Flat Bush Primary School – Notice of Requirement Integrated Transportation Assessment

Flat Bush Primary School Notice of Requirement – Integrated Transportation Assessment

Appendix A.
Response Table from Auckland Transport & Auckland
Council Feedback

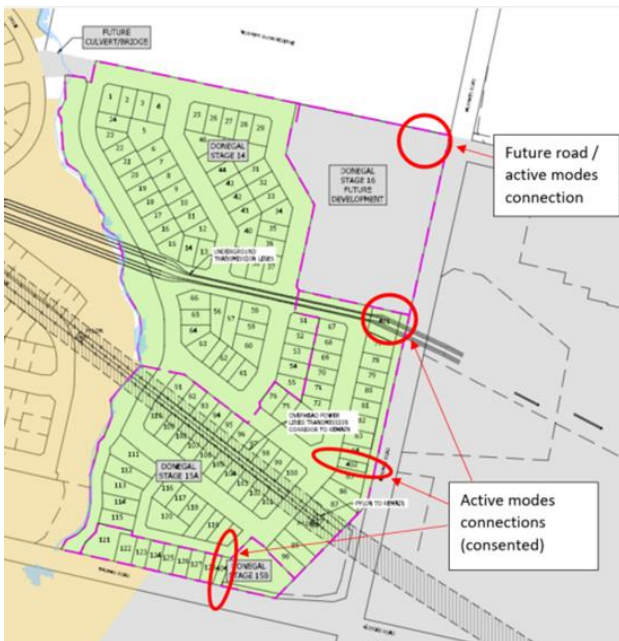
<p>Walking and Cycling</p> <ul style="list-style-type: none"> • Assessment should detail the walking catchment for the school and assess the adequacy of infrastructure including the area immediately west of Murphys road. There is insufficient commentary around walking and cycling (and wheeling), planning for vulnerable road users needs to be prioritised. Walking and cycling should be considered as the principal mode of access 	<p>The walking catchment for the school lies to the south-east of the school site. This area is made up of newly constructed local roads with footpaths on both sides, designed to cater for low speeds and have safe crossing points. These roads provide an excellent environment for active modes.</p> <p>There is no walking or cycling provision on Murphys Road and it is unlikely that any interim mitigation prior to the full upgrade of</p>

- The stream crossing from Picturesque Drive will mitigate private vehicle trip generation and contribute to a reduction in emissions, this should link the cycle facility on the other side of the stream promoting school access by active mode and increasing the viability of the proposed remote PUDO.
- ITA should pick up on discussion between MoE and AC Parks regarding an esplanade path continuing South and West from the SE corner of #12 esplanade path through to Murphys Road. This has been planned in the RC and EA for BUN60397121
- The provision of a new school on the subject site will be a significant draw for residents west of Murphys Drive given the travel distance to existing schools. As such a signalised crossing of Murphys Road to connect with Donegal path network must be provided.

Murphys Road will be a safe solution for school students. The ITA assumes that school students will only be travelling from the southeast, resulting in no demand on Murphys Road.

The distance from the remote PUDO to the school site is approximately 450m which equates to a 5-minute walk (via the soon to be constructed and vested walkway through 125 Murphys Road development). This short distance does not warrant the very high expense of an active modes bridge across the stream. We believe the remote PUDO will be successful if managed well through the School Travel Plan and walking school bus programme.

The Ministry has investigated a stream crossing, and received a quantity surveyor estimate of \$2m. This is not considered to be a scale of mitigation commensurate with the transport effects of this school proposal, specifically considering the crossing would only be reducing a 450m walk. The ITA explains how the remote PUDO can be implemented and the proposed designation conditions address this expectation including through use of a travel plan, that the school must continue to operate.

Pick up Drop Off, parking and internal circulation

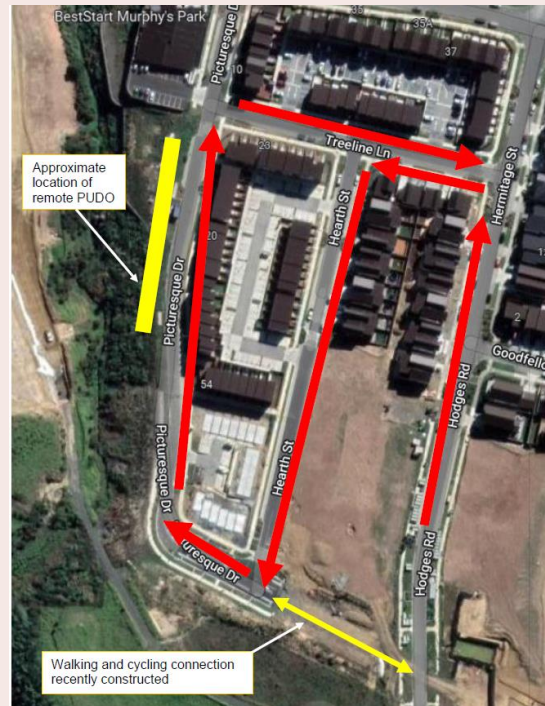
- The east end of the road being constructed by #125 must be reconfigured to form a forward turn head (11 m radius). This end of the road will become effectively PUDO.

Agreed. MOE propose to form both ends of Road 3 into forward turning heads if considered necessary at next stage of design.
